SUBJECT: Focused Corrective Measures Study/Feasibility Study for D-Area Ash Basin Wetlands (NBN) in Support of the Savannah River and Floodplain Swamp Integrator Operable Unit (U) (SRNS-RP-2024-01034, Revision 1, May 2025) (Redline Pages) and Savannah River Site's Responses to the Regulatory Comments on the Revision 0 Document SEMS Number: 69

**SRS Responses to USEPA Comments on the Focused Early Action Corrective Measures
Study/Feasibility Study for the D-Area Ash Basin Wetlands (NBN) in Support of the Savannah
River and Floodplain Swamp Integrator Operable Unit,
SEMS Number: 69, SRNS RP-2024-01034,
Revision 0, Dated October 2024
Savannah River Site, Aiken, South Carolina**

**SRS Responses to South Carolina Department of Environmental Services Comments on the Focused Corrective Measures Study / Feasibility Study for D-Area Ash Basin Wetlands (NBN) in Support of the Savannah River and Floodplain Swamp Integrator Operable Unit (U),
SRNS-RP-2024-01034, Revision 0, Dated October 2024**

Figure CR-1. Arsenic and Potassium-40 Levels in Sediment/Soil Within the 0-1 ft and 0-4 ft-Depth Intervals

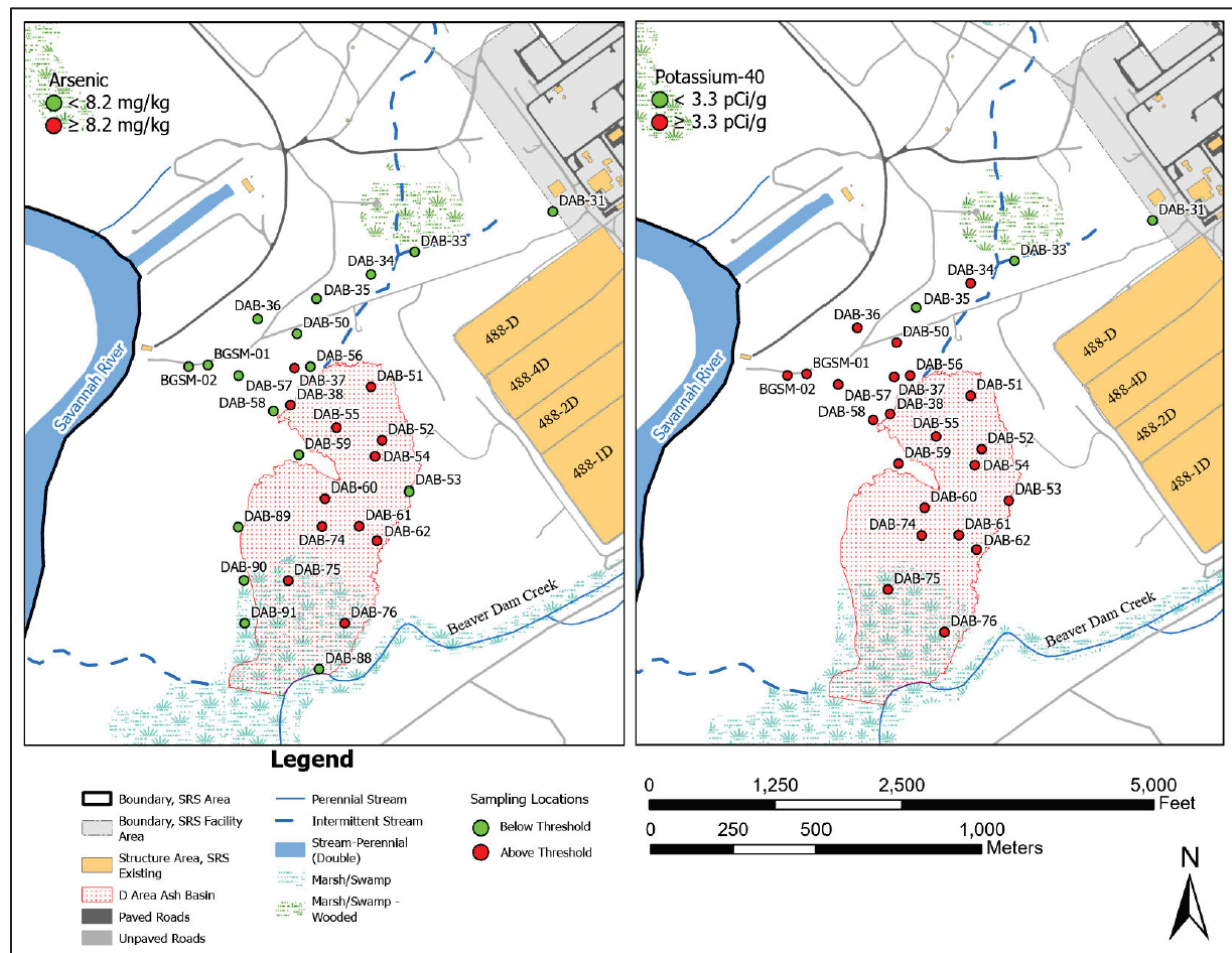
1. The CMS/FS does not consistently describe the extent of the coal ash at the D-Area Ash Basin Wetlands (DABW). Section 1.2.2 (Nature and Extent of Contamination) states that the ash deposition area is considered the boundary of the wetland, but the red area shown on Figure 2 (Layout of the D-Area Ash Basin Wetlands) does not line up with the wetlands shown in the figure (e.g., the marsh/swamp is not in the northern area and extends further south than the DABW area). Further, based on Figure 10 (Arsenic and Potassium-40 Levels in Sediment/Soil within the 0-1 ft and 0-4 ft Depth Intervals) and Figure 11 (Thorium-232 and Uranium-238 Levels in Sediment/Soil within the 0-1 ft and 0-4 ft Depth Intervals), elevated concentrations of contaminants of concern (COCs) above the preliminary remediation goals (PRGs) are found outside the DABW boundary (i.e., uranium-238 at DAB-37, arsenic at DAB-37 and DAB-39, and potassium-40 at DAB-37, DAB-39, DAB-56, DAB-57, and DAB-58). As such, it is unclear if ash is found at these locations. *Please revise the CMS/FS to clarify the locations and extent of ash found at the DABW and how the extent of ash was determined based on the results presented on Figures 10 and 11.*

2. The COCs in sediment/soil that exceed PRGs have not been delineated as shown by the red sample locations on Figure 10 (Arsenic and Potassium-40 Levels in Sediment/Soil within the 0-1 ft and 0-4 ft Depth Intervals) and Figure 11 (Thorium-232 and Uranium-238 Levels in Sediment/Soil within the 0-1 ft and 0-4 ft Depth Intervals). For example, all potassium-40 sample results exceed the PRG [though its noted that K40 is always natural background and not site-related], and all of the results for the northern sample locations exceed the arsenic PRG. Therefore, it is unclear if the extent of the proposed land use controls (LUCs) boundary in Alternative A-2 (see Figure 12, Proposed Land Use Control Boundary Based on Ash Extent [represented by As and background cleanup level of 8.2 mg/kg]) and the estimated volume of contaminated media to be excavated under Alternative A-3 are sufficient to meet the remedial action objective (RAO). The CMS/FS should discuss whether additional delineation or a buffer zone outside the LUC boundary will be considered to address the areas outside the LUC boundary where sediment/soil exceeds PRGs. *Please revise the CMS/FS to discuss the delineation of the COCs in the sediment/soil at the DABW.*

Additionally, Figures 10 and 11 inadvertently did not include all sample locations used in the risk evaluations and will be corrected in the Revision 1 document as shown in Figures CR-1 and CR-2.

Figure CR-4. Layout of the D Area Ash Basin Wetlands

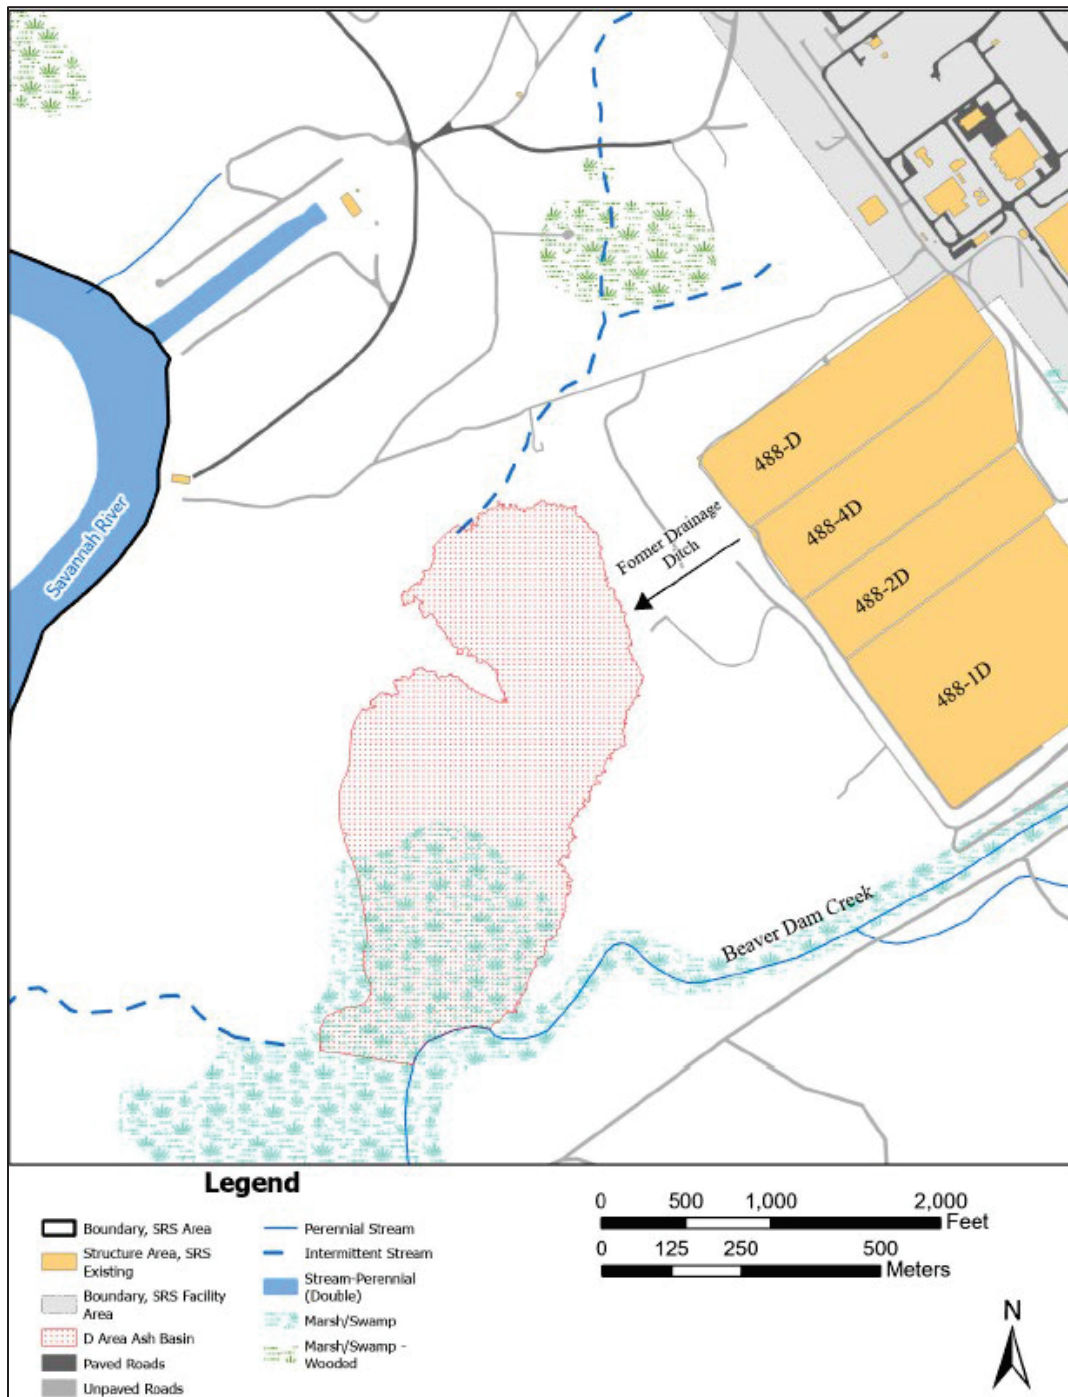
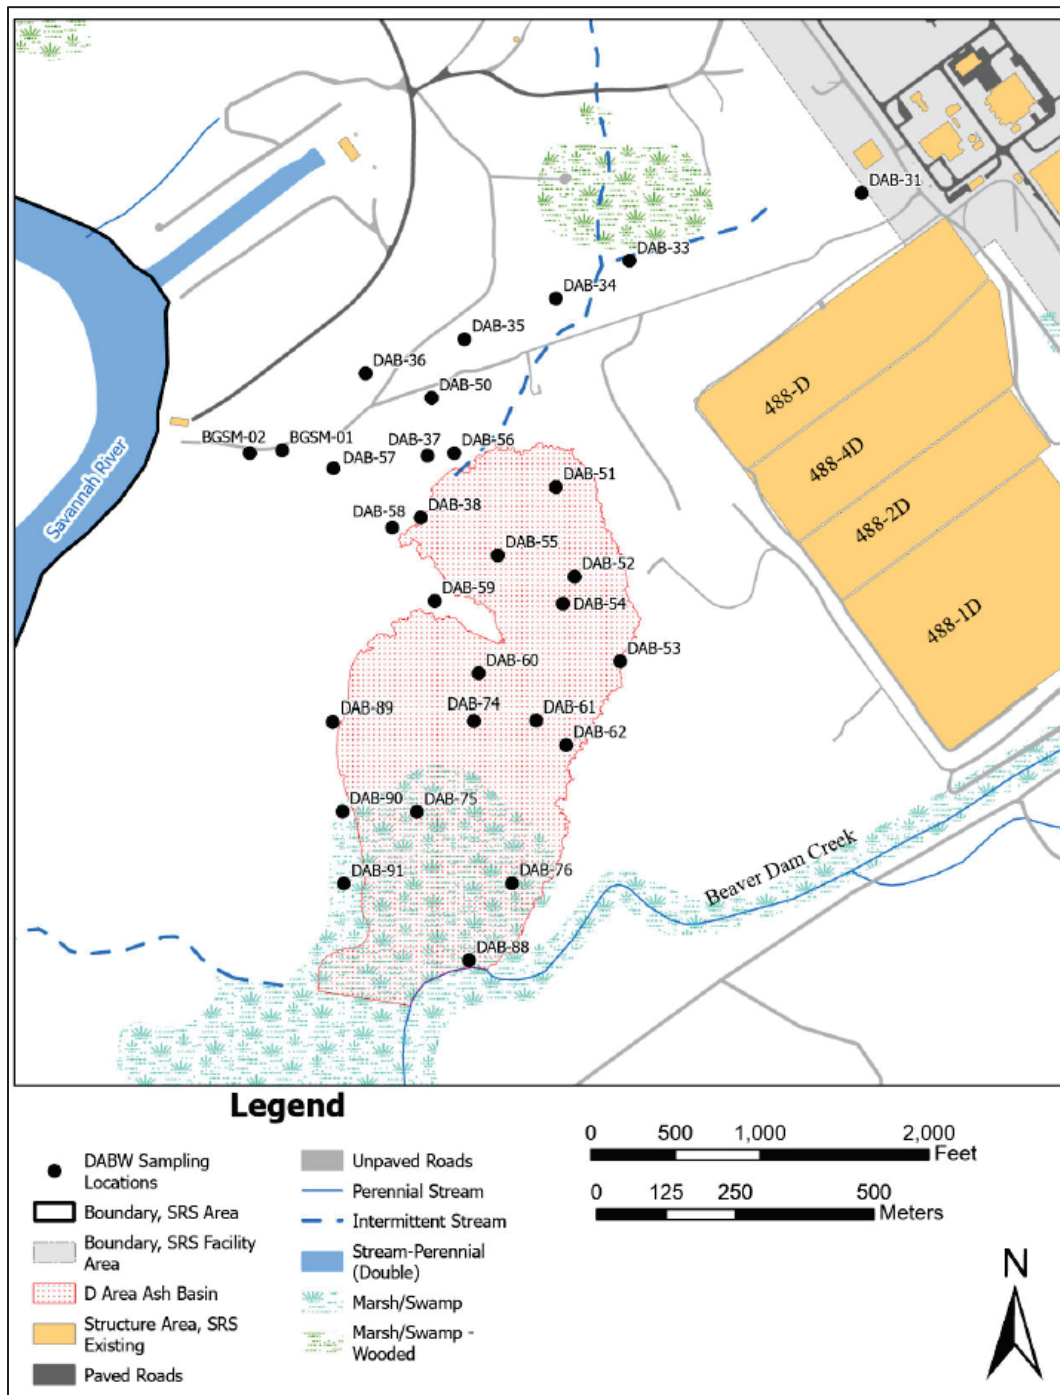
1. **Section 1.2.1, Unit Description, Unit History, Page 1-6 of 1-14:** The text states that the ash is believed to have been deposited in the DABW via an upgradient drainage ditch, but further discussion of this ditch is not provided. It is unclear if the location of the ditch is known and if it has been characterized for ash COCs. It is also unclear whether this ditch is included in the DABW

or if it will be addressed under a different remedial action. Finally, the location of the ditch is not shown on Figure 2 (Layout of the D-Area Ash Basin Wetlands). *Please revise the CMS/FS to discuss the location of the drainage ditch and how it will be addressed. Please also include this drainage ditch on Figure 2.*

Figure 2 will be revised as shown in Figure CR-4 to identify the location of the former drainage ditch.

Figure CR-6. D-Area Ash Basin Wetlands Topography and Water Table Contours

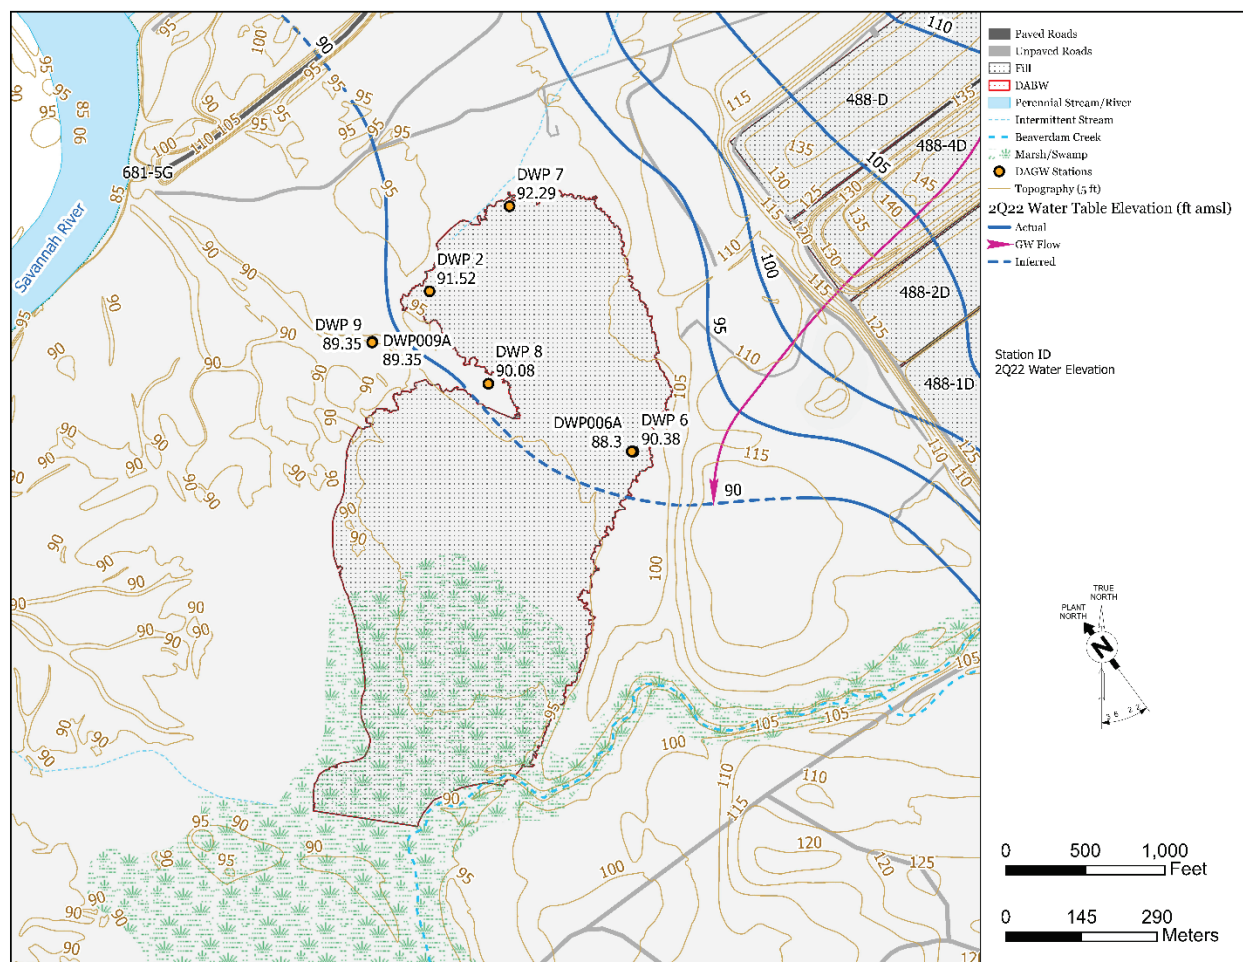
7. **Figure 7, D-Area Ash Basin Wetland Topography and Water Table Contours, Page 6-10 of 6-38:** The water table contours from 2018 are shown on this figure, but the groundwater elevations relative to mean sea level are not provided to support the contours. It is also unclear if these are the most recent water levels measured, as arsenic results from 2023 are provided on Figure 8 (D-Area Ash Basin Arsenic Results for Groundwater [2Q23]). *Please revise Figure 7 to include the most recent groundwater elevation measurements to support the water table contours and groundwater flow direction.*

Figure 7 depicts the potentiometric surface for the second quarter of 2022 (2Q22) but the legend was not updated. Figure 7 will be revised to correctly label the potentiometric surface, as well as to present the 2Q22 water elevation data to support the presented potentiometric contours and groundwater flow direction. The revised Figure 7 is included in these responses to comments as Figure CR-6.

Figure CR-7. Refined CSM for the D-Area Ash Basin Wetlands

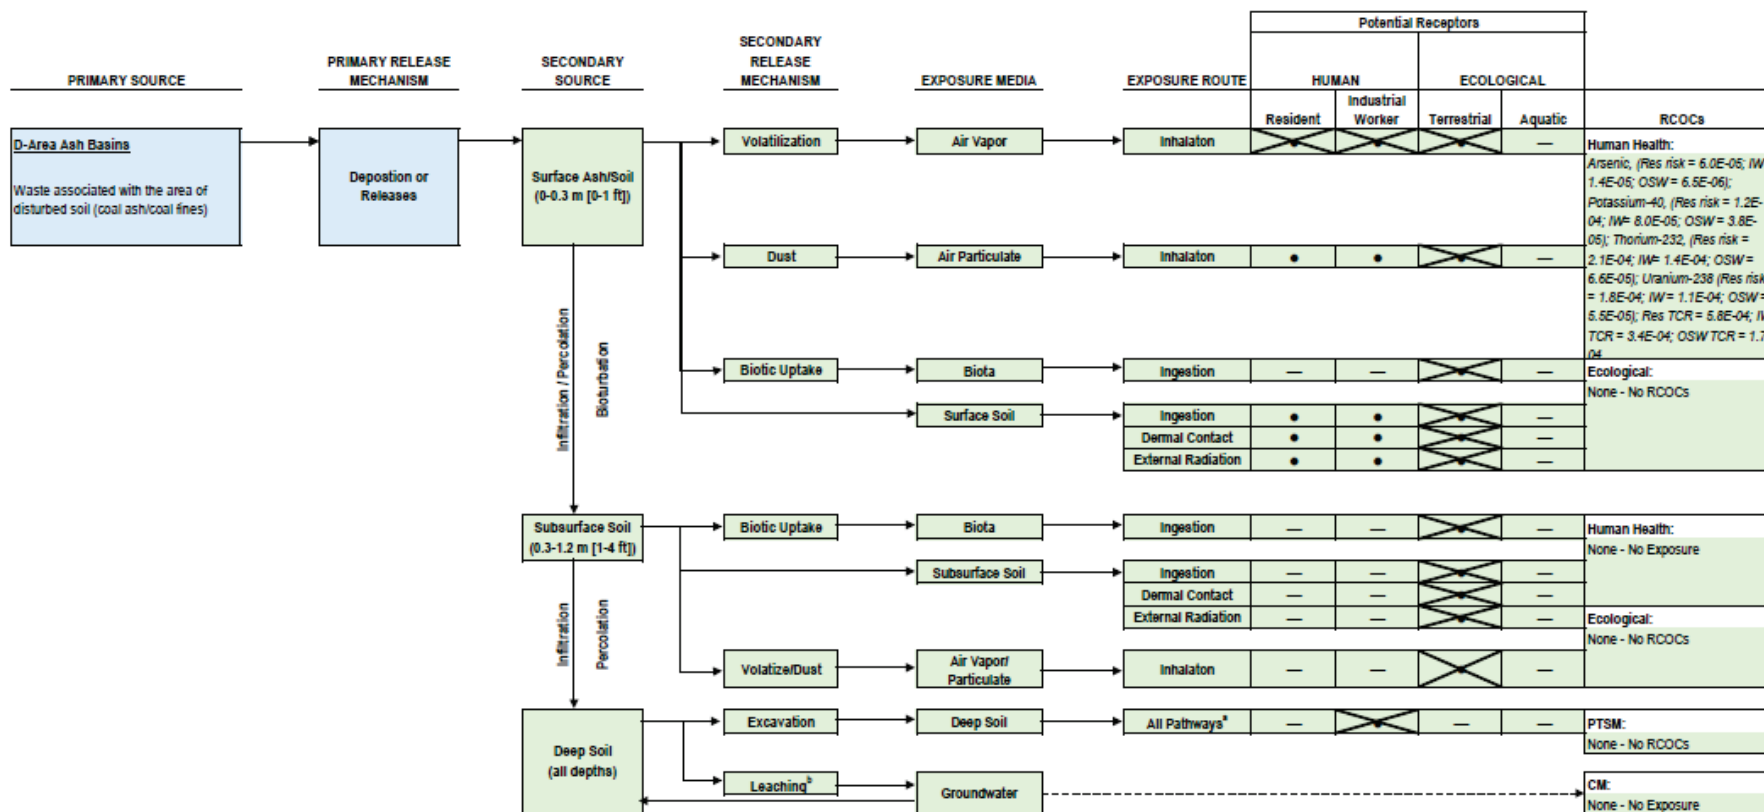
8. **Figure 9, Refined CSM for the D-Area Ash Basin Wetlands, Page 6-12 of 6-38:** There are no volatile constituents of concern in sediment/soil investigated in the HHRA; therefore, the boxes for inhalation of vapors (resident and industrial worker) should contain dashes to indicate an incomplete exposure pathway. *Please revise the conceptual site model figure accordingly.*

Volatile constituents were evaluated in the HHRA; however, none were identified as RCOCs. Therefore, the human health receptor boxes for inhalation of air vapor should be revised to indicate no RCOCs were identified. The Refined CSM will be revised as shown in Figure CR-7.
